M12 Motorway

Amendment Report

October 2020

Figure 4-1 Location of ancillary facilities as described in the EIS and proposed additional and amended ancillary facilities

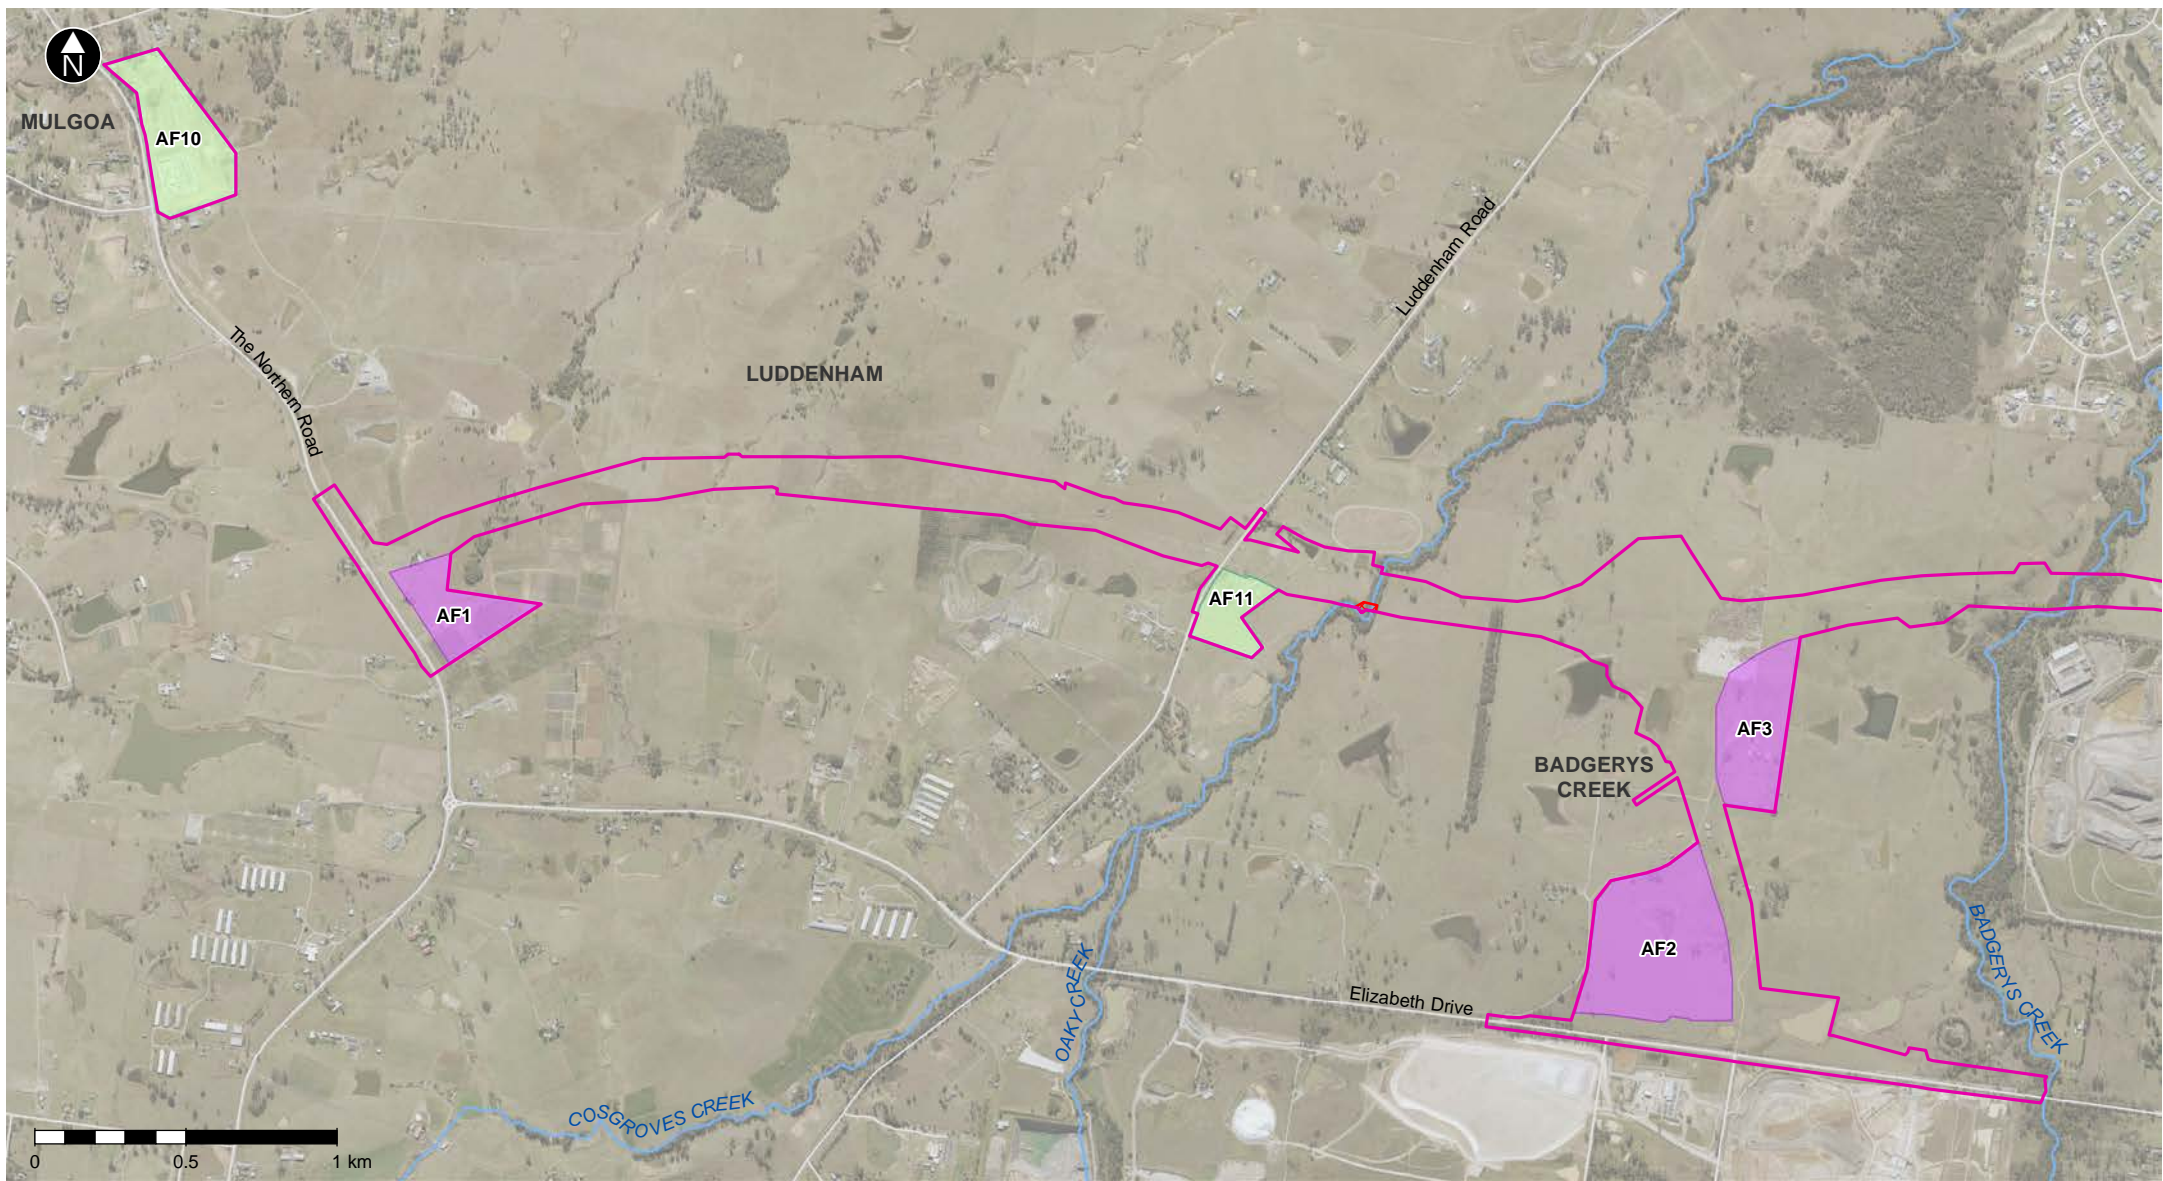
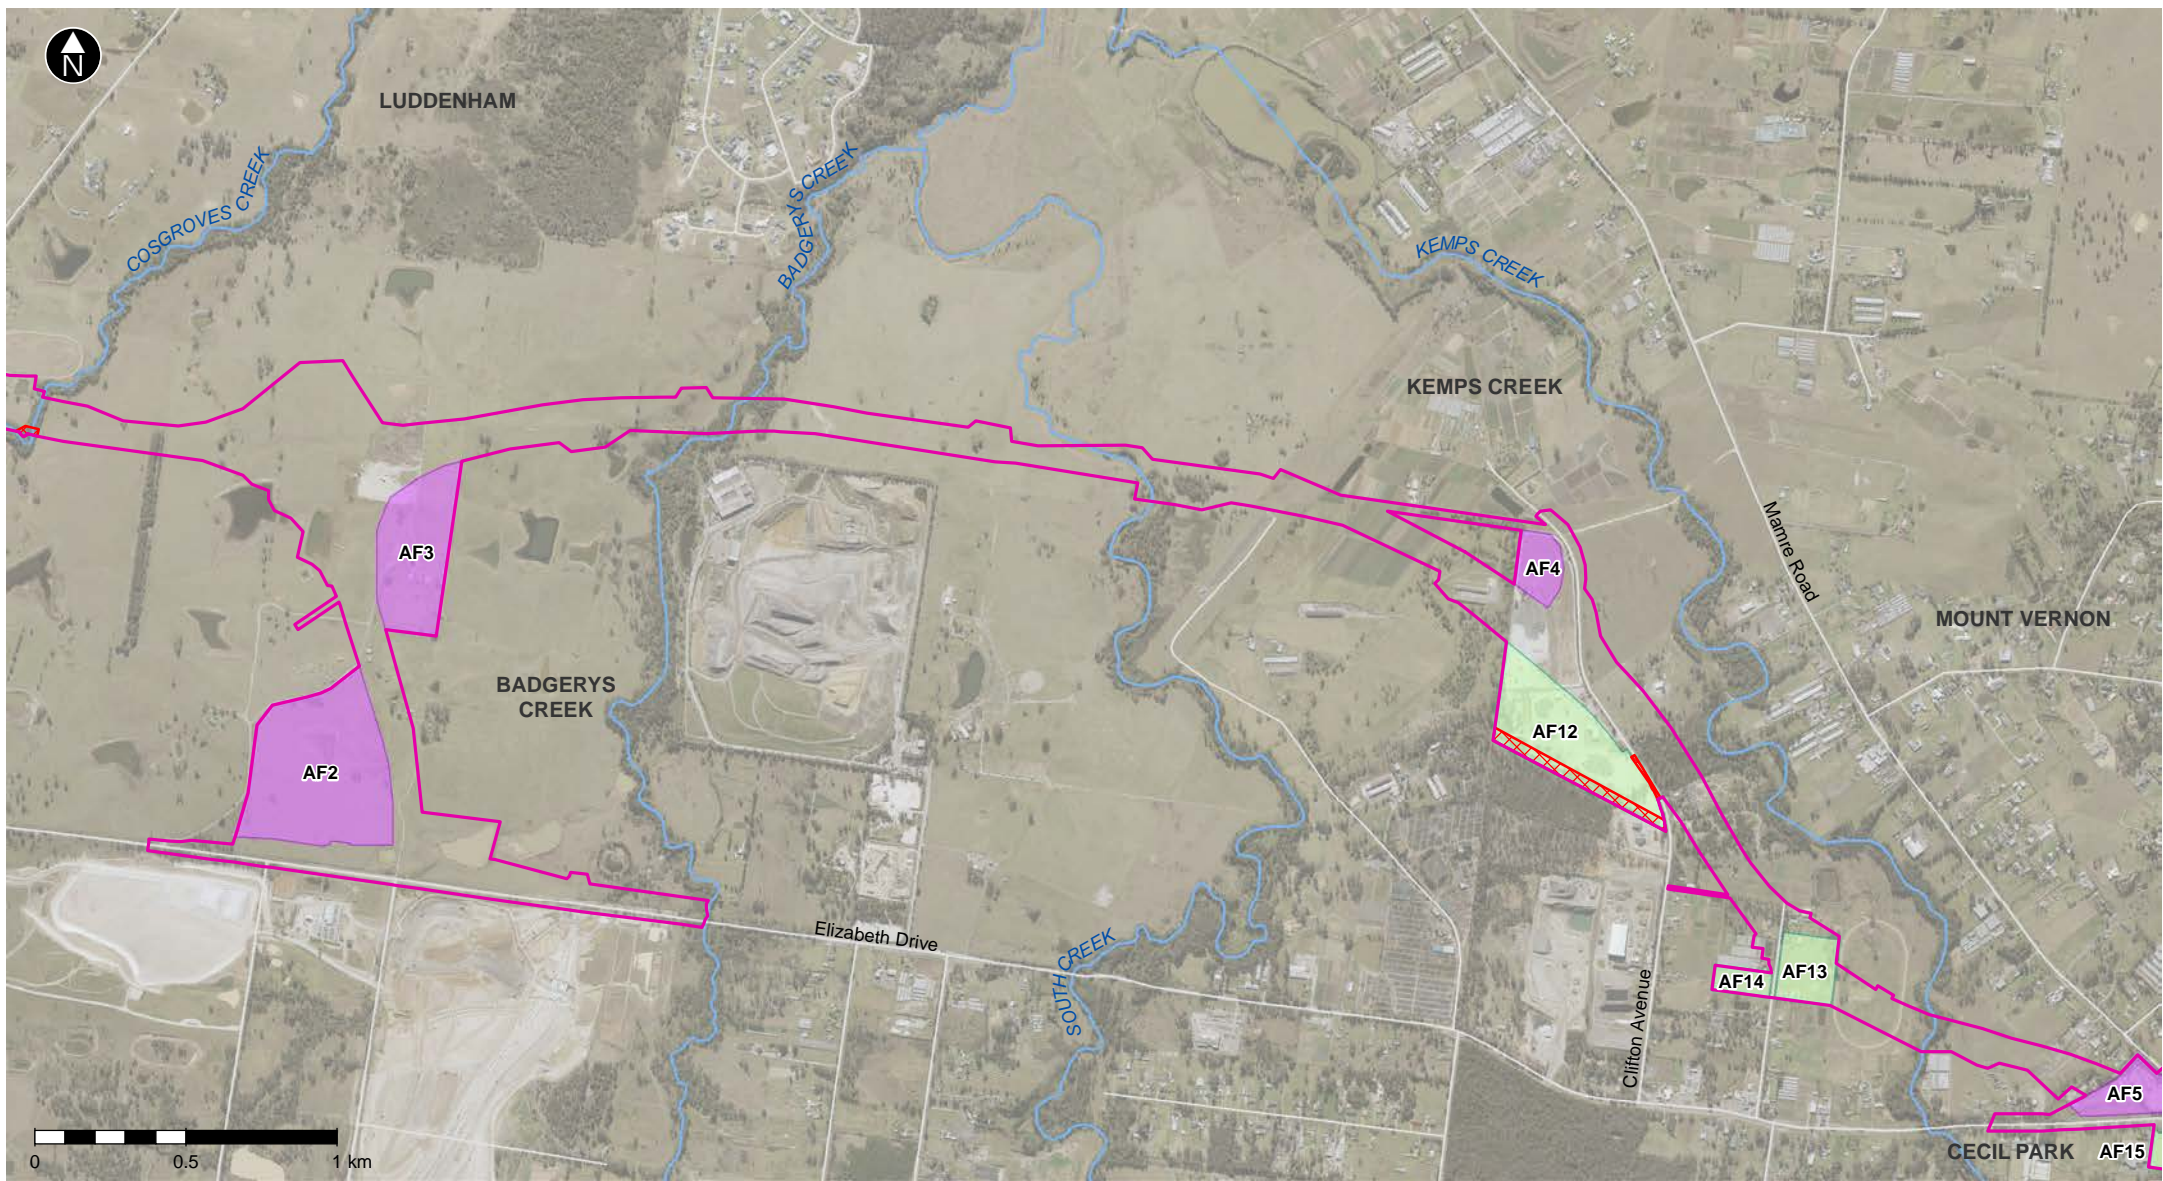
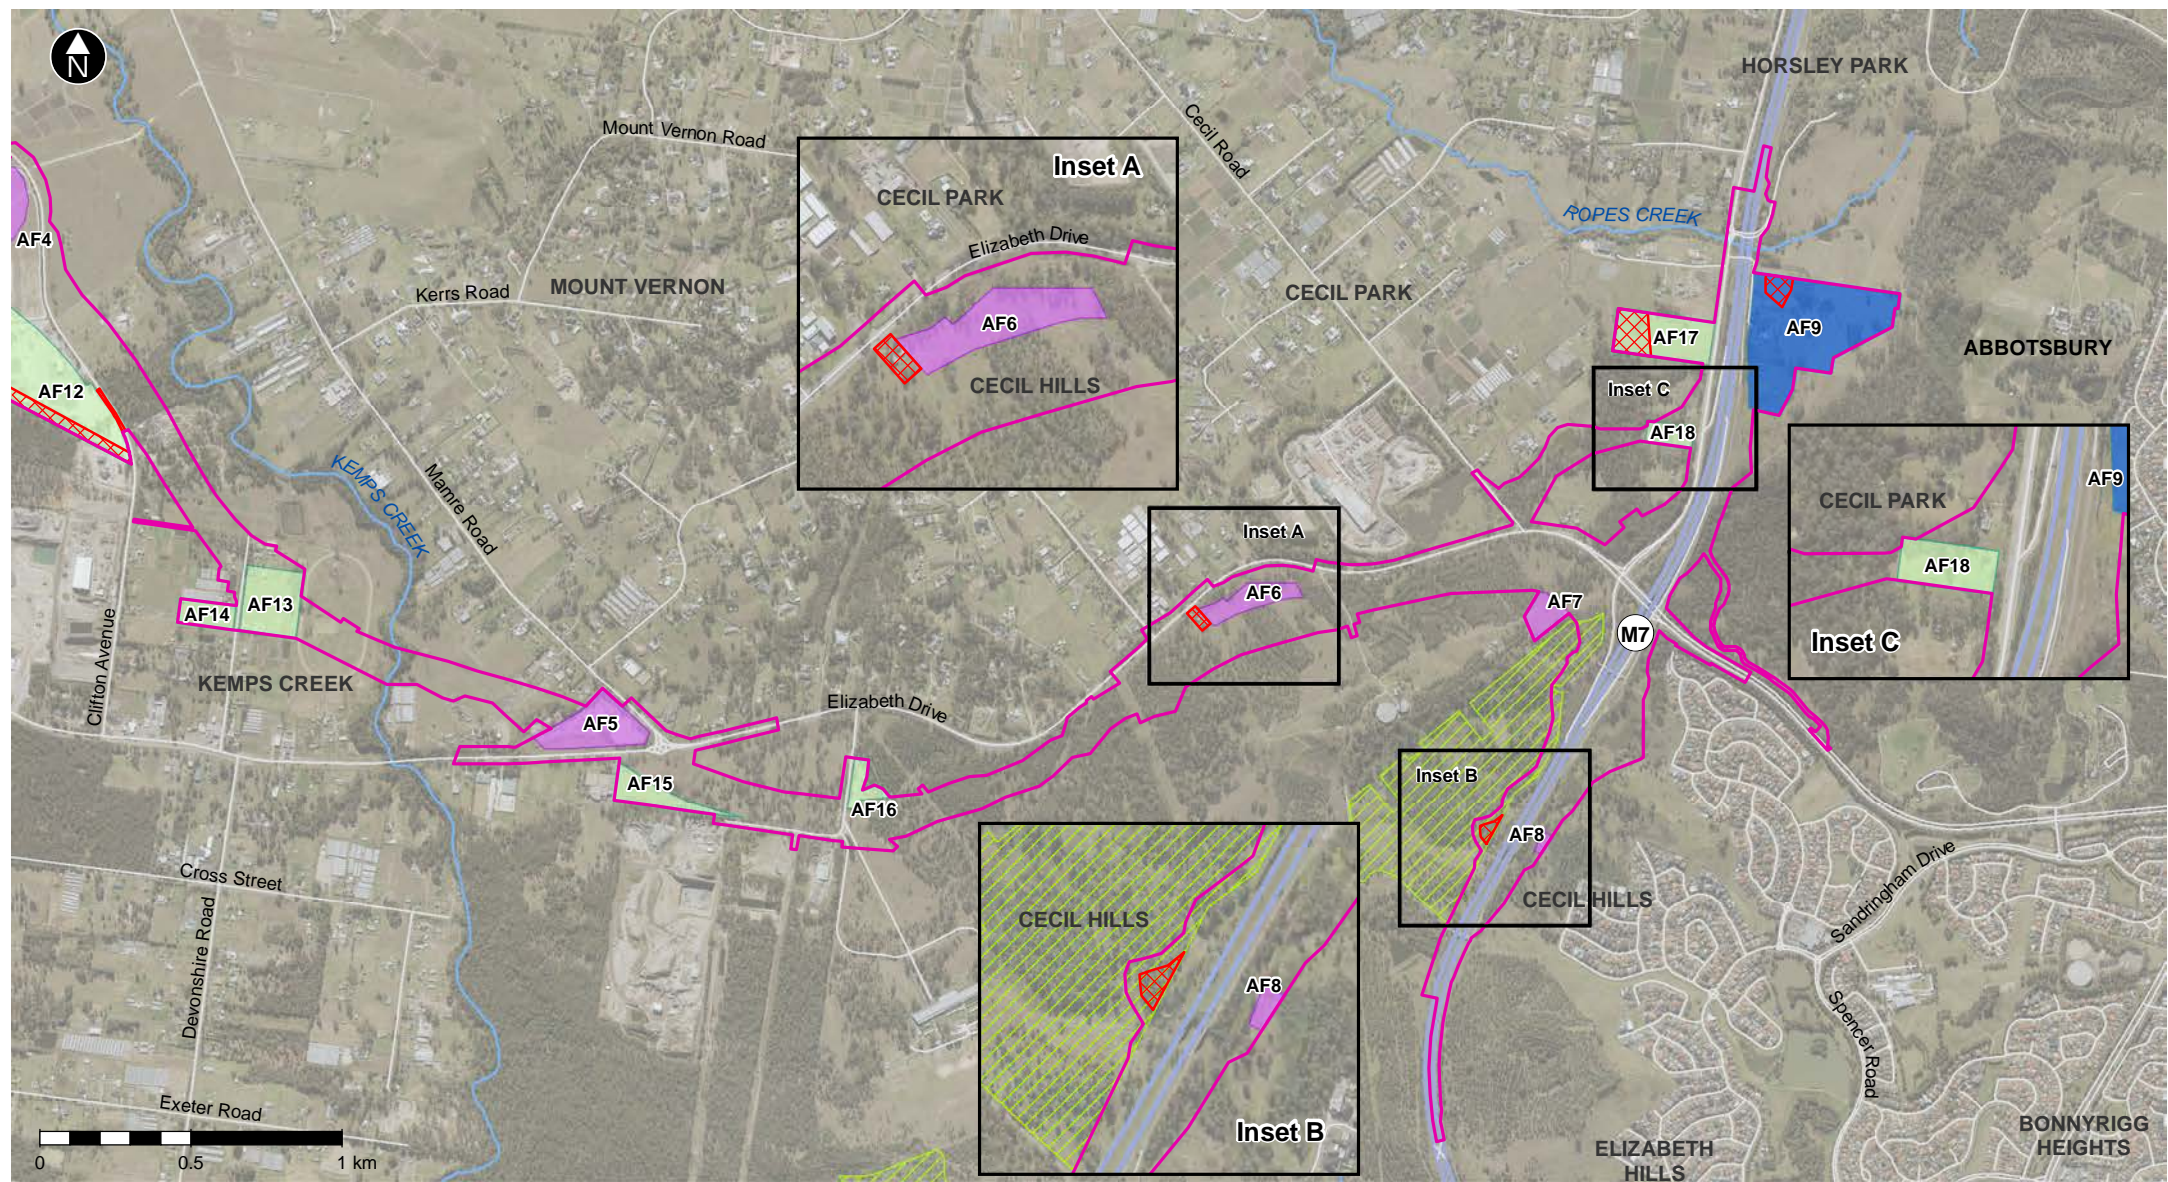
The additional and amended ancillary facilities and their locations are described in **Table 4-1** (with changes to the ancillary facilities as described in the EIS shown in **bold text**) and **Figure 4-1**.

Figure 4-3 Additional farm dam to be impacted as part of amended project

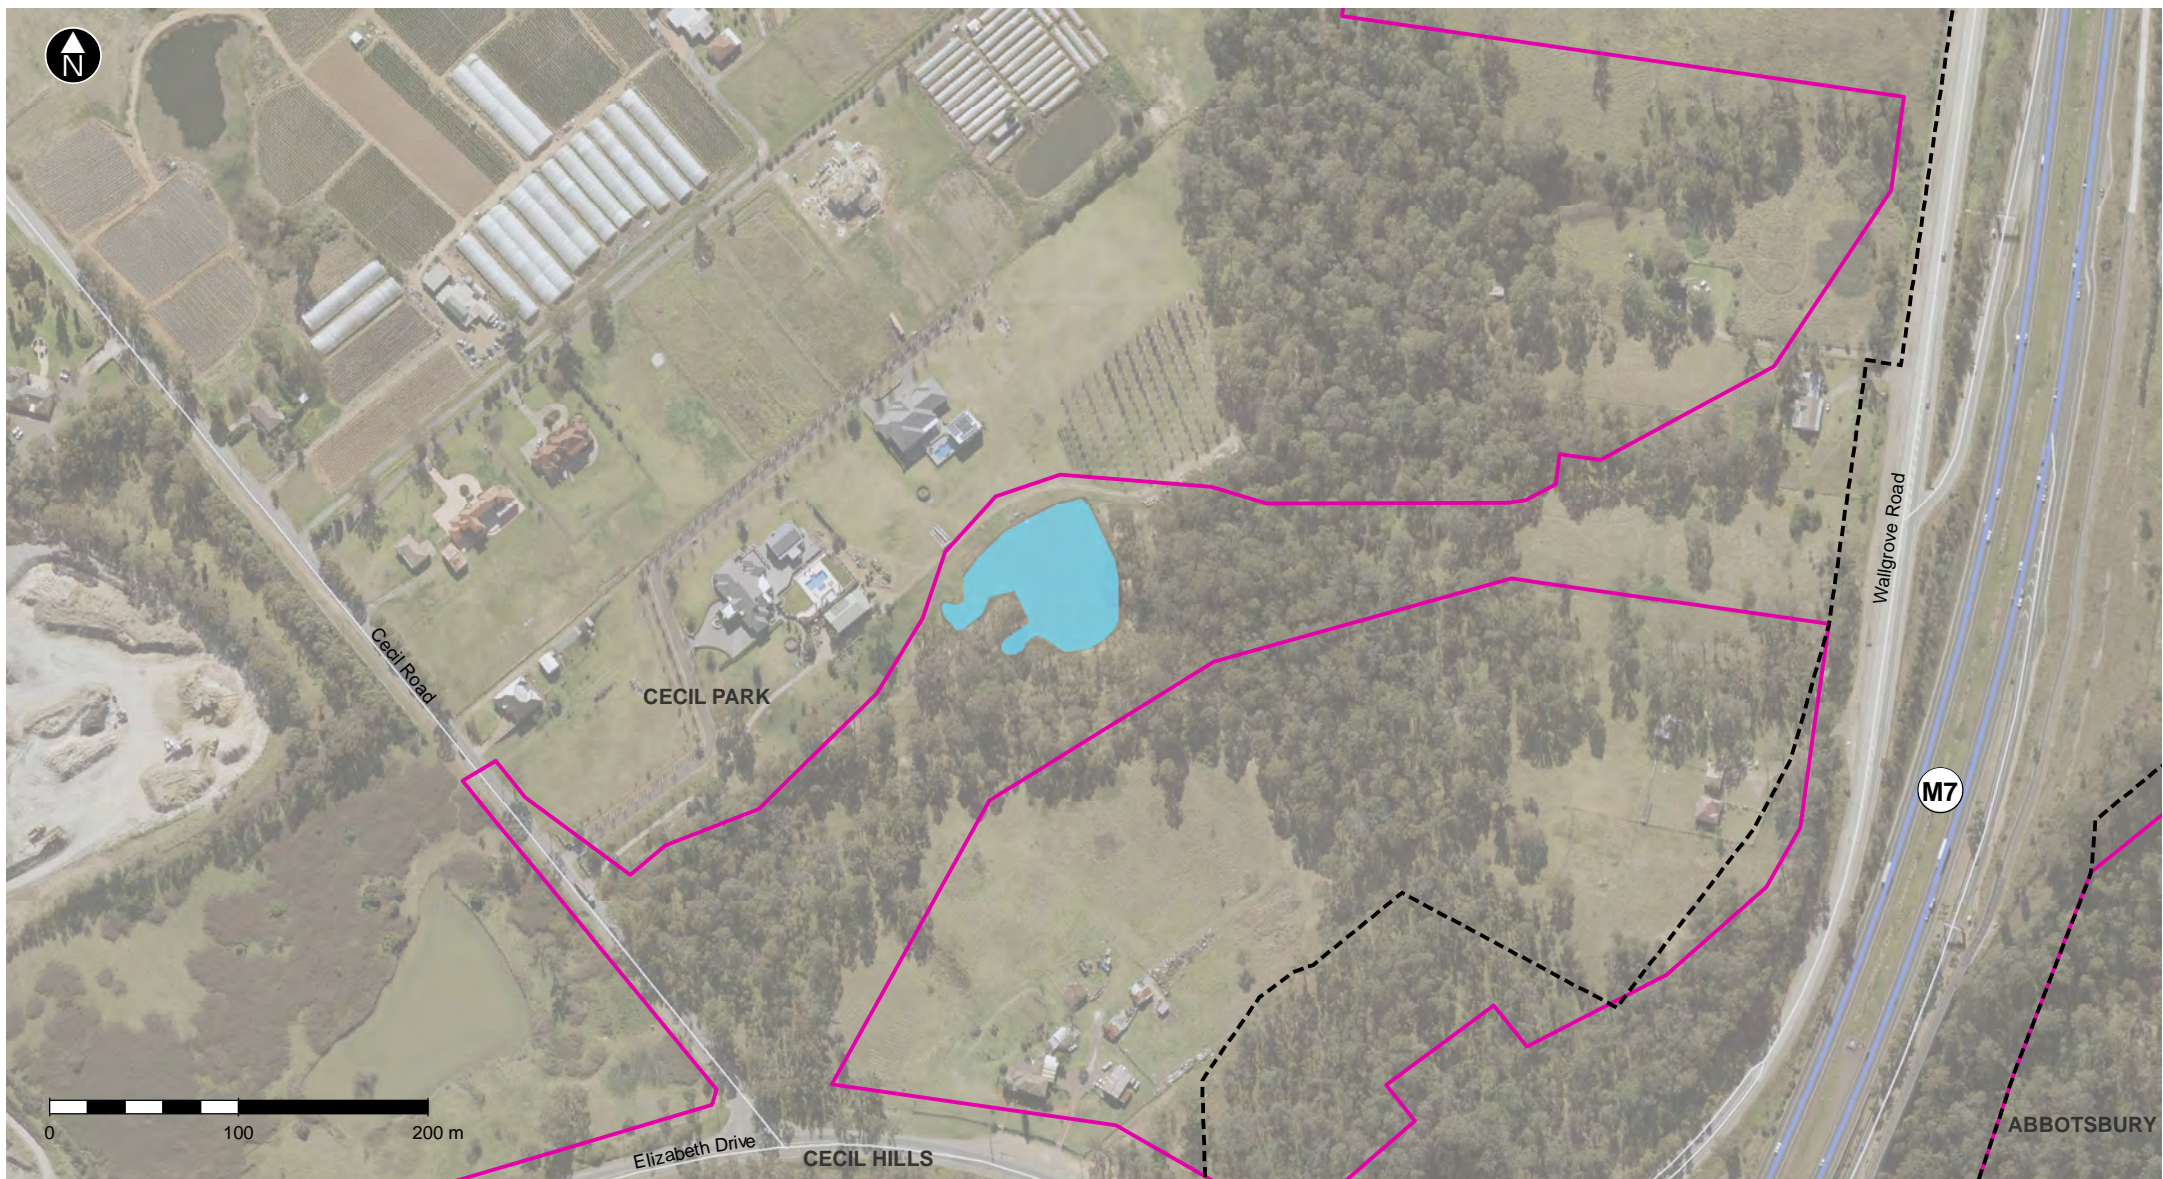
The amended project would impact one additional farm dam that would be located within the amended construction and operational footprints (see **Figure 4-3**). As a result, a total of up to 16 farm dams may require de-watering and either full or partial infilling to construct the amended project.
